INC. VILLAGE OF FREEPORT

JANUARY 20, 2023
AMENDED LETTER OF DENIAL
Updated

RE: 307 Guy Lombardo Avenue, Freeport, New York
Zoning District – Business B Sec. 62 Blk. 080 Lot 6
Building Permit Application #20190921 – Use building for church assembly

FIRST FLOOR
 SCALE: 1/4" = 1'-0"

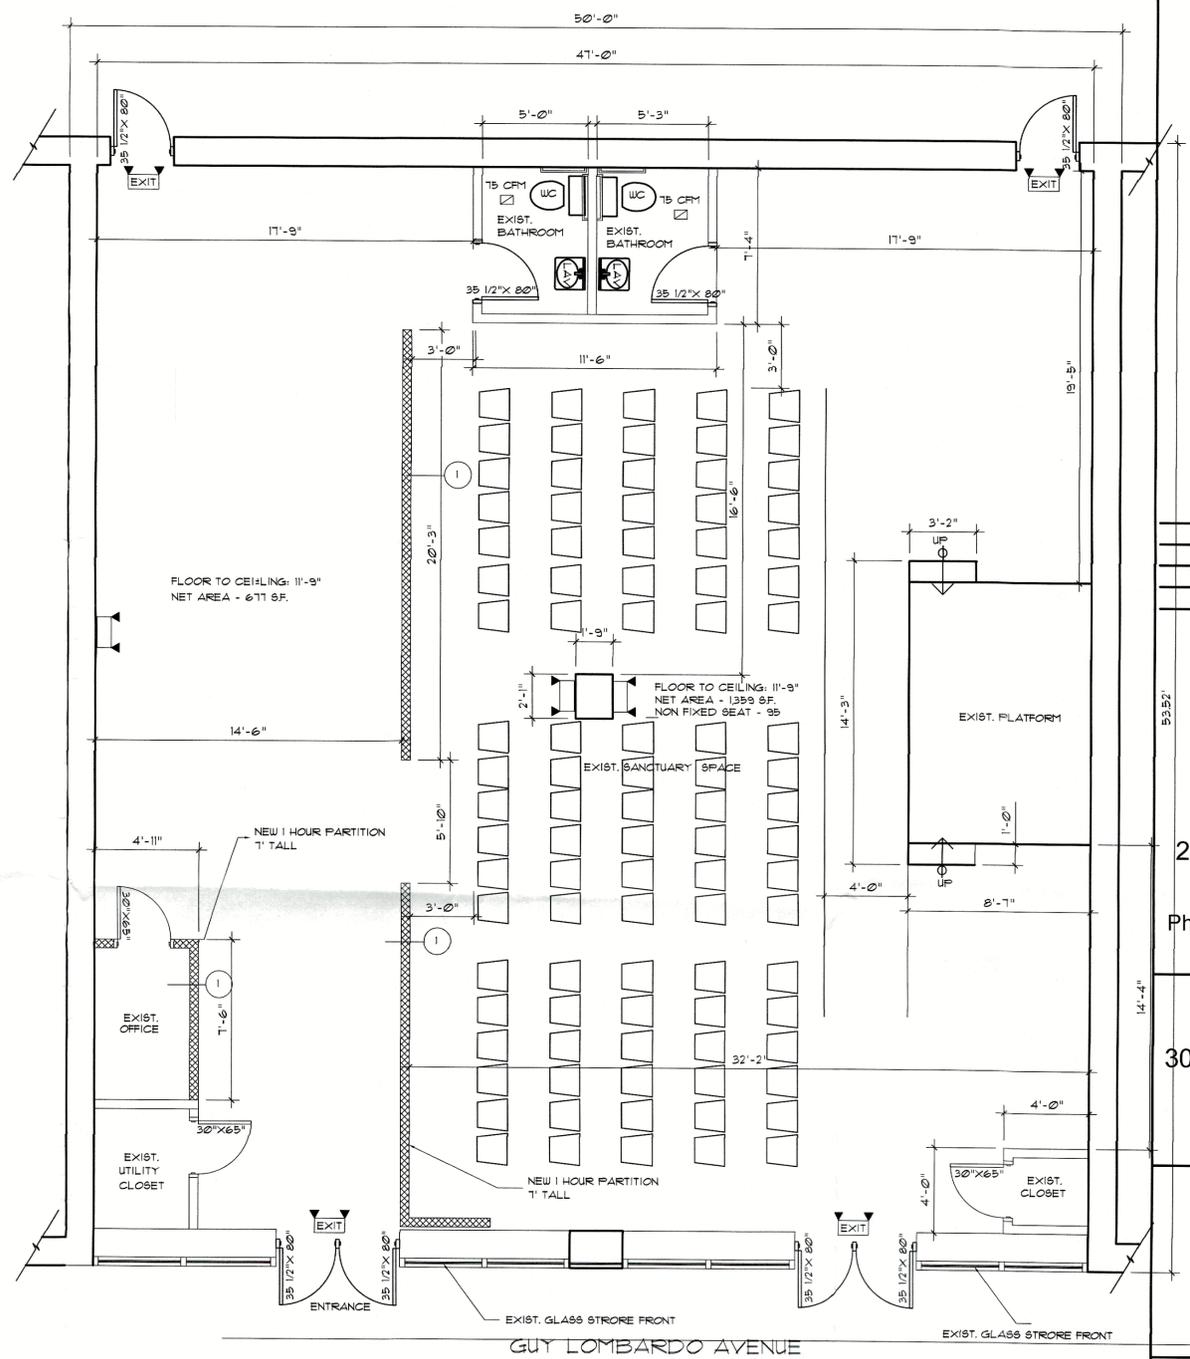
- 1) **Village Ordinance §210-6A. Conformity required:** No building or land shall hereafter be used or occupied and no building or part thereof shall be erected, moved or altered unless in conformity with the regulations herein specified for the district in which it is located.
- 2) **Village Ordinance §210-172(3). Required parking spaces:** Places of public assembly, including churches, temples and religious auditoriums, but excluding restaurants, discotheques, cabarets and bars: at least one parking space for each three seats provided, based on maximum seating capacity. **The plan that you have submitted with your application implicates a seating capacity of 345 persons (3/345=115 parking spots). You are only providing five (5) parking spots. Accordingly, you will be seeking a variance for 110 parking spots.**

SECTION 303
 303.4 ASSEMBLY GROUP A-3
 TABLE 1004.3 (ICC)
 ASSEMBLY - (CHAIRS ONLY NOT FIXED) - 5 NET
 NET AREA - SANCTUARY (1359 SF. / 5 NET) = 272 PERSON
 PROPOSED SEATING LAYOUT (95 PERSONS)
 STANDING SPACE - 5 NET
 NET AREA - STANDING SPACE (671 SF. / 5 NET) = 45 PERSON
 VILLAGE ORDINANCE 210-172(3)
 TOTAL PERSONS (272 + 45) = 317 PERSON / 3 = 105 PARKING SPACE
 THEREFORE NON COMPLIANCE.
